Panmark Apparels (Pvt) Ltd

18 December 2025

2. Building Information

Observation-01: Stress in the strip footing exceeds the normal design limit. (Main Production Building)

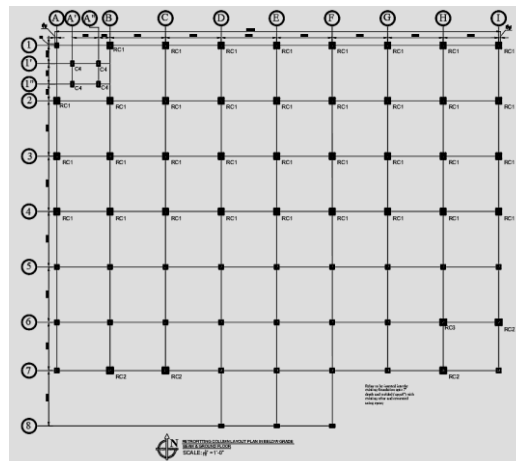
Description: During the inspection and document review, preliminary calculations indicated that the typical strip footings (CF1 and CF2) of the Main Production Building are below the required design capacity. In addition, one footing was shown as retrofitted in the drawings; however, no credible supporting documents were found on site.

The factory is required to engage a qualified structural and geotechnical consultant to:

- Verify the dimensions of the existing and retrofitted footings and review the design assumptions, applied loads, and foundation stresses.
- Conduct a Detailed Engineering Assessment (DEA) based on verified onsite data & material strength.

Observation-02: Inconsistency in the design report and lack of lateral stability system at Roof Shed.
(Main Production Building)

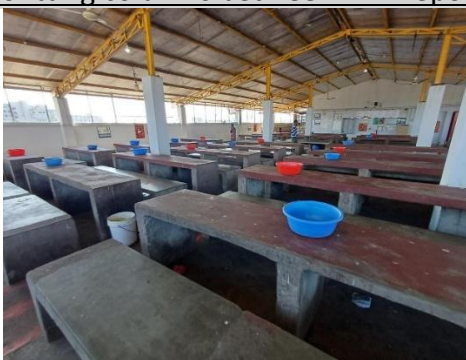
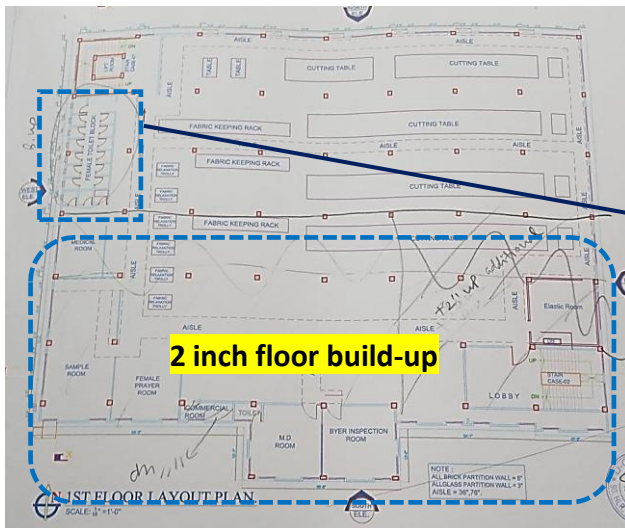
Discrepancy in no. of retrofitting columns between DEA report and retrofitting drawing

Concrete dining table has excess dead load at roof top which not considered in DEA

Incomplete serviceability, irregularity, and foundation adequacy checks in the design report.

Lack of lateral stability at Roof Shed

Description: A design report has been prepared for the Main Production Building; however, several inconsistencies were identified in the DEA report.

- A total of 80 columns are recommended for retrofitting in the design report, whereas a lesser number is shown in the retrofitting drawings.
- At the rooftop dining area, excessive dead loads from concrete seats and tables were observed; however, these loads were not considered in the FEA model.
- Detailed and proper adequacy checks for serviceability, structural irregularities, and foundation stresses were not incorporated in the design report.

Also, no load transfer media or no lateral load resisting bracing was found at the roof shed of the Main Production Building.

The Building Engineer is required to revise the design documents, check the lateral stability of the roof shed and submit all the required documents to RSC for detail review.

Observation-03: Discrepancies in the as-built and retrofitting drawings. (Main Production Building)

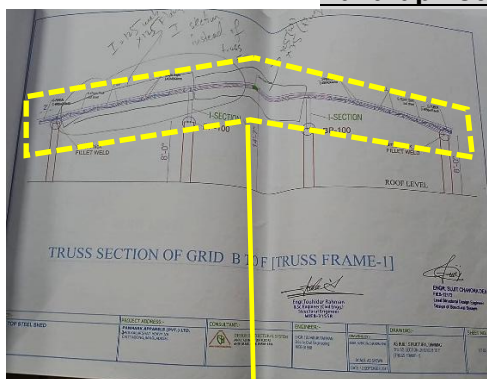
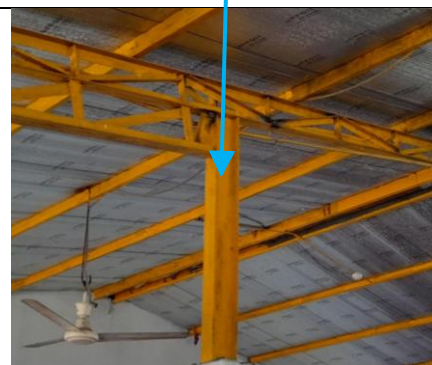
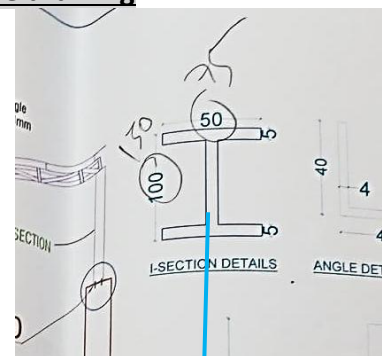
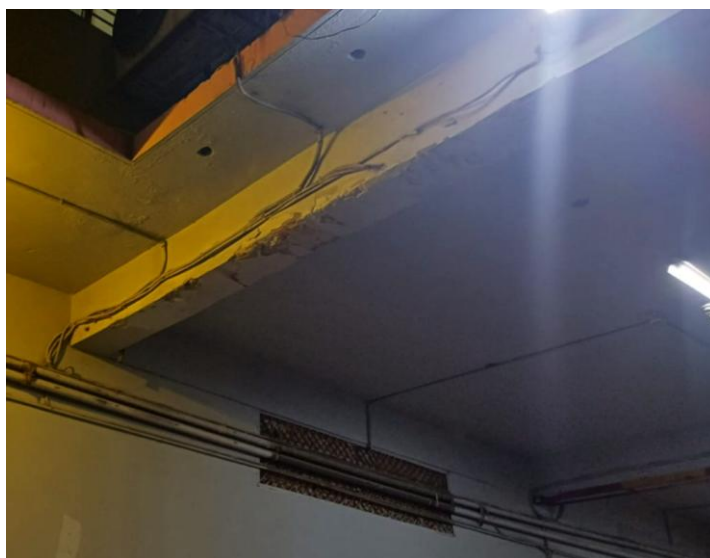
Build-up not mentioned in the drawing

I section found instead of truss at F-grid

Section size mismatch

Description: During inspection, Several inconsistencies were observed in the as-built and retrofitting drawings, as outlined below-

- 2-inch floor build-up was observed at the 1st floor (south side) but is not shown in the architectural drawings. Additionally, toilet floor build-ups for all floors are not mentioned.
- In the retrofitting drawings, the F-grid is shown as a truss; however, an I-section was found on site. Furthermore, the steel column sections shown in the as-built drawings do not match the actual site condition.

The Building Engineer is required to survey the full structure and prepare as-built as well as retrofitting drawings as per actual site condition.

Observation-07: Incomplete as-built drawings. (Sub-station and Boiler Room)

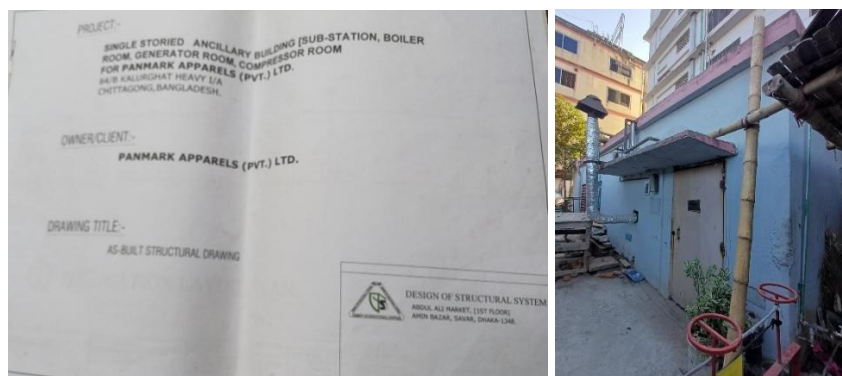
Description: During inspection, complete as-built drawings with detailed information on structural members were not available on-site. The building engineer is required to prepare and submit a complete set of as-built drawings, reflecting the actual site conditions, to RSC for review.
